Second Regulation 25 Response	
Hamble Lane Reg 25, Hampshire	
Job number:	J0801
Document number:	J0801/1/F1
Date:	16 October 2023
Client:	CEMEX
Prepared by:	Mr Bob Thomas

**Figure 1: Mineral Site  $\text{PM}_{10}$  Increment as a Function of Distance from Quarry Operations by Mineral Type**

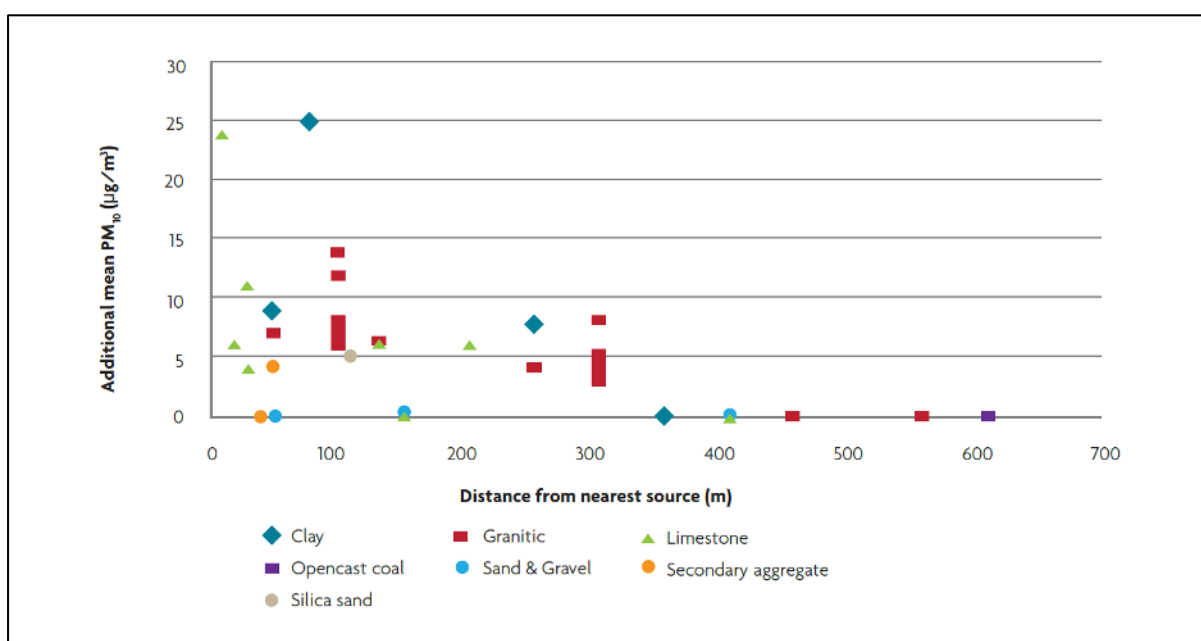
- “Evidence should include complaints histories, measurements of TPM, PM<sub>10</sub> and PM<sub>2.5</sub> at various distances and directions from site boundaries and the effects of variation in relative humidity and wind speed on dust migration and secondary dust emissions. Modelling techniques, such as polar plots could use this data to help demonstrate source attribution, effects of wind speed and direction etc. Any conclusions drawn could be used to support the assumptions made during the qualitative assessment of the proposed site.”*

- 2.1.22 Cemex do not have monitoring data from similar sand and gravel quarries that it operates; however, data is available in Appendix 2 of The Institute of Air Quality Management (IAQM)<sup>3</sup> Guidance on the Assessment of Mineral Dust Impacts for Planning (2016). The IAQM Guidance includes graphs showing the fall-off in PM<sub>10</sub> concentrations with distance from the source at mineral sites, produced using data provided by members of the IAQM Mineral Guidance Working Group. A graph showing the mineral site PM<sub>10</sub> increment as a function of distance from quarry operations by mineral type has been reproduced in **Figure 1** below. **Figure 1** shows that sand and gravel quarries are likely to increase PM<sub>10</sub> concentrations be less than 1µg/m<sup>3</sup> (almost zero) at distances of around 50m, 150m and 400m from quarry operations.

2.1.25 It is considered that undertaking  $\text{PM}_{10}$  monitoring at the application site would not provide any useful additional information with regard to determining the baseline air quality, and that  $\text{PM}_{10}$  monitoring of baseline air quality, and the extended analysis of monitoring data, should not be required for the planning application. There are currently no significant  $\text{PM}_{10}$  emissions sources at the application site, or in the local area, and it is considered that the estimated baseline  $\text{PM}_{10}$  concentration determined by adding the Defra background concentration to the road emissions contribution from the dispersion model provides an appropriate estimate of baseline  $\text{PM}_{10}$  concentrations for the planning application. Monitoring of baseline air quality would be undertaken prior to works commencing, as set out in the DMP for the scheme, if the proposed development is granted planning consent.

**Figure 2: nPPG PM<sub>10</sub> Assessment Framework**

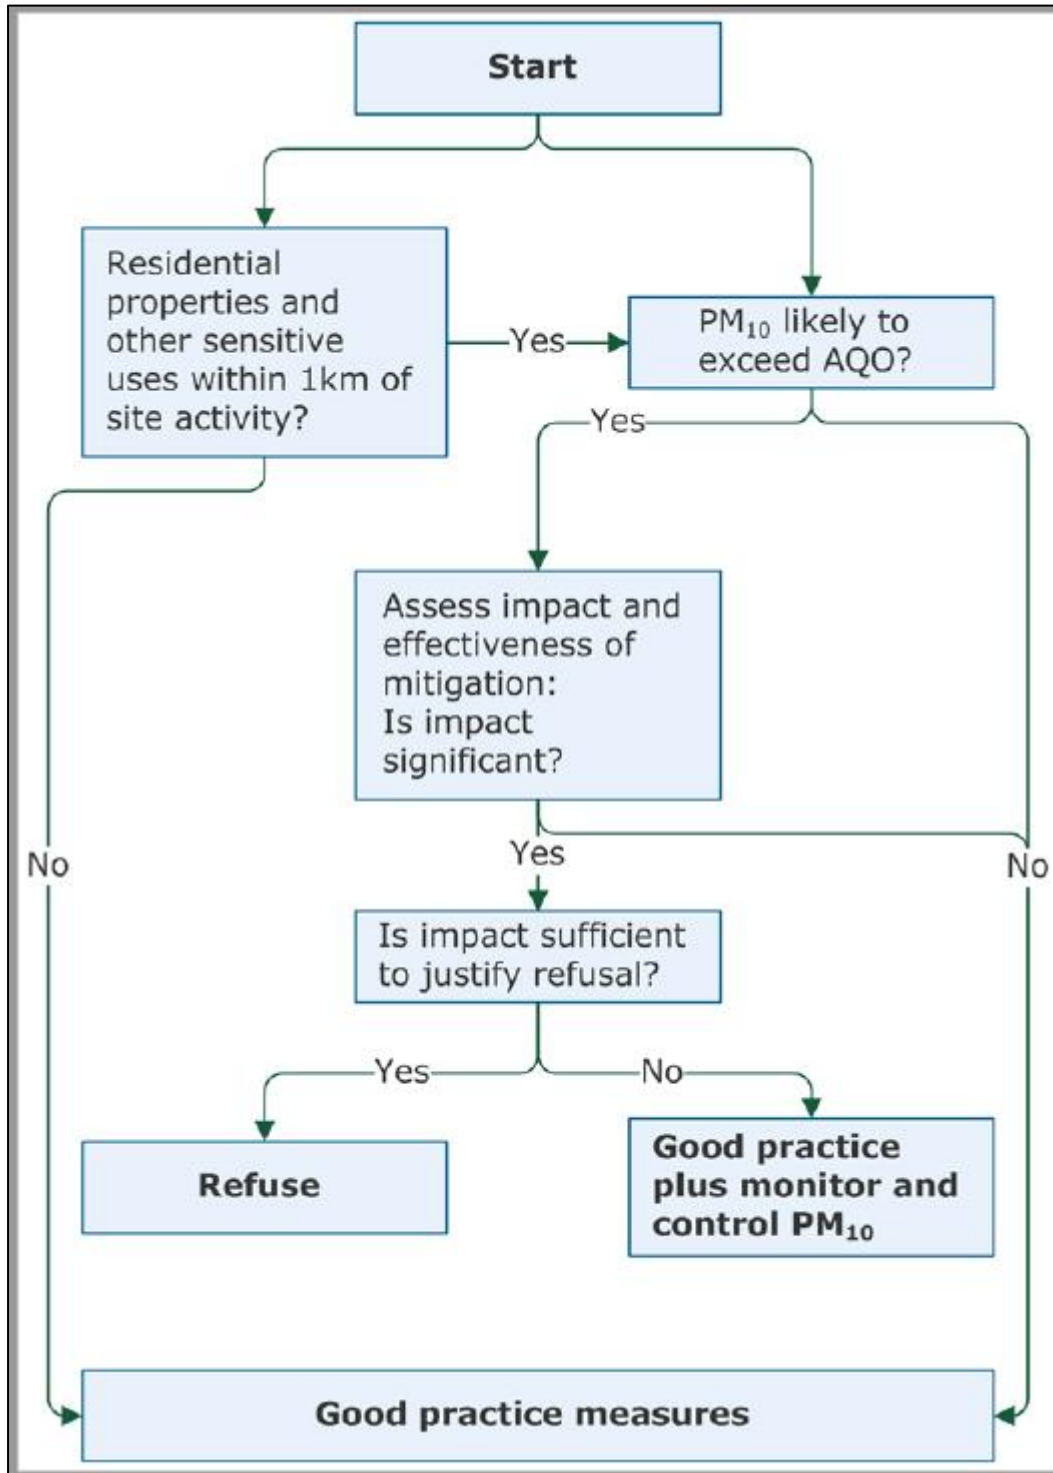
*"we do not accept the premise that simply not exceeding current UK thresholds demonstrates that there is no risk to health."*

2.1.32 The assessment framework is a site assessment flow chart, reproduced at **Figure 2**<sup>5</sup>. The assessment framework is clear that, where PM<sub>10</sub> concentrations are not likely to exceed the AQOs, good practice measures should be sufficient, without the need for monitoring and specific controls on PM<sub>10</sub> emissions.
